KMR.CDD.LyQ.1922.05

ORDER UNDER SECTION 96 (2) OF ACT, III OF 1901.

MUNICIPAL ENGINEER'S OFFICE,
Karachi, 23. 5. 1922.

With reference to ^{his}~~their~~ application, dated 18. 8. 1922.Mr. Haroon Demail is informed
~~Messrs.~~ ~~are~~that the plan submitted by ^{him}~~them~~ for building a water -Trough for public use
on plot No. 2 Survey Sheet K 28situate in Koonharwara Street,
Road LyallQuarter, is approved, and permission to build in accordance therewith is
granted. The building to be erected, subject to the By-laws and Rules of the
Municipality.Nali*Permission granted
Subject to the condition
that he makes no encroachment
on municipal road.*

— SITE PLAN SHOWING THE EXISTING PIPES & POSITION
OF PROPOSED WATER TROUGH AT MUKAM MEWASHAH
KARACHI —
Scale 400 feet to 1 inch —

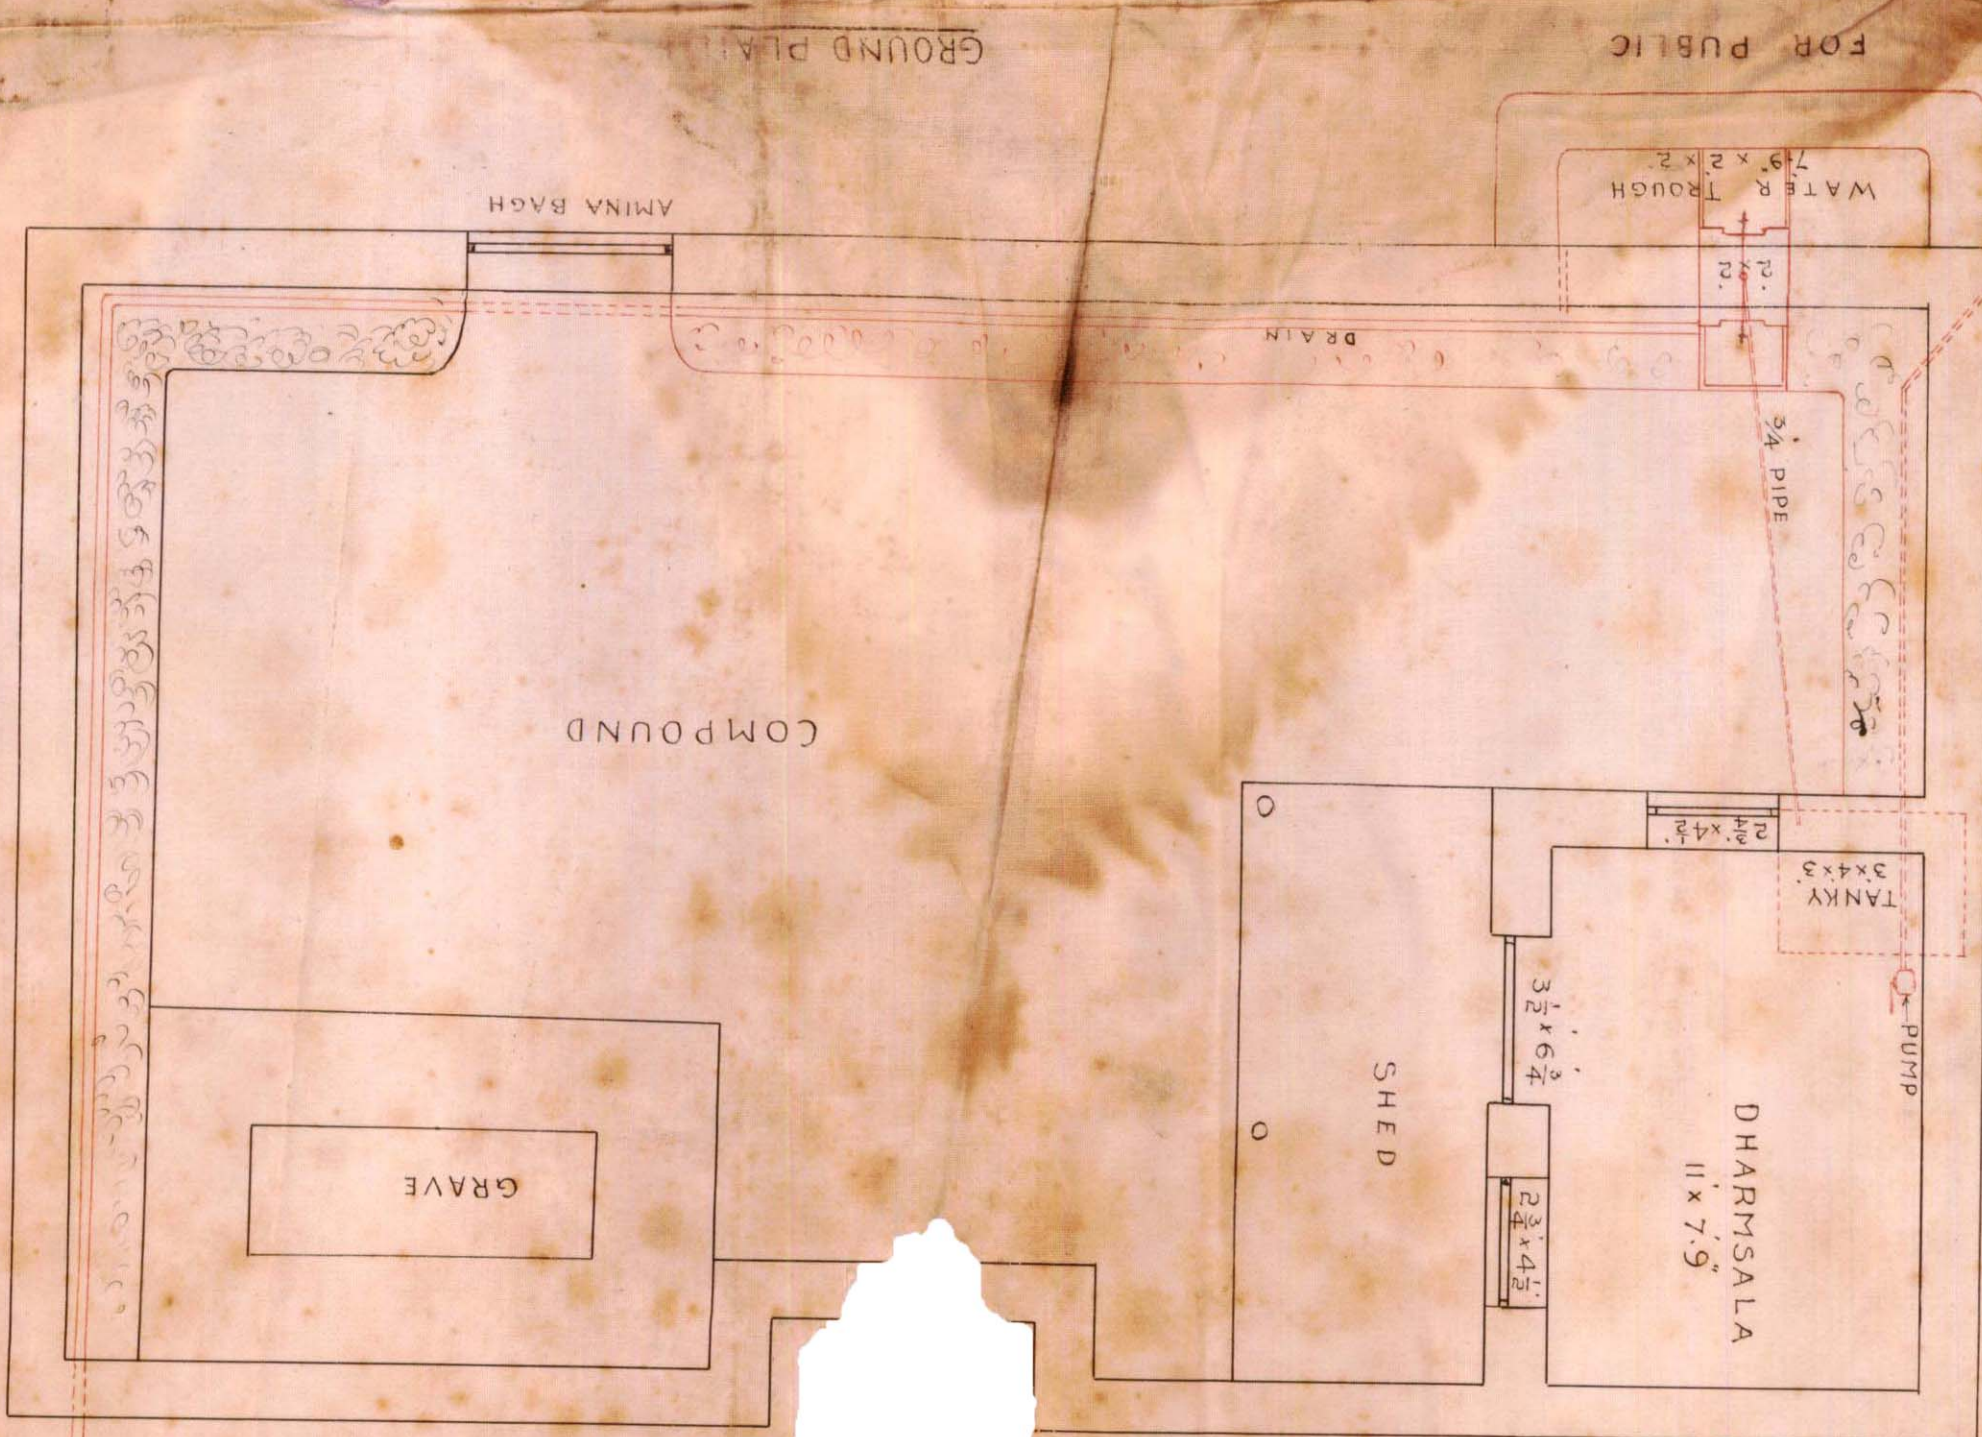
Submitted with F.C. If the Mahammadan Community erect the water-trough in their own name & allow Mr. Haroon to bear the expenses, there will be no objection to granting such permission to the M. Community as the pipe line 2" diam. is the property of that Community.

In reply to your letter dated the 8th ultimo, I have to inform you that objection to the proposed site of the water trough is that a very long length of piping will be required to connect it up with the Municipal Water Main. No piping was included in the former estimate of the cost and it is found that the cost will now amount to Rs 4,000/- If this sum is deposited with the Municipality the work will be taken in hand providing it is distinctly understood that the Municipality will take no responsibility in the matter of supply of water or maintenance.

It will be necessary to lay a new pipe from the proposed site to the main line. The cost of this considered in the estimate was prepared & if not what will be the additional expenditure 24/4 B

The cost of 1" dia
4.2. pipe line from the municipal
main to the proposed site will be
as follows. It was not included in
the estimate: which was prepared
only for water trough.
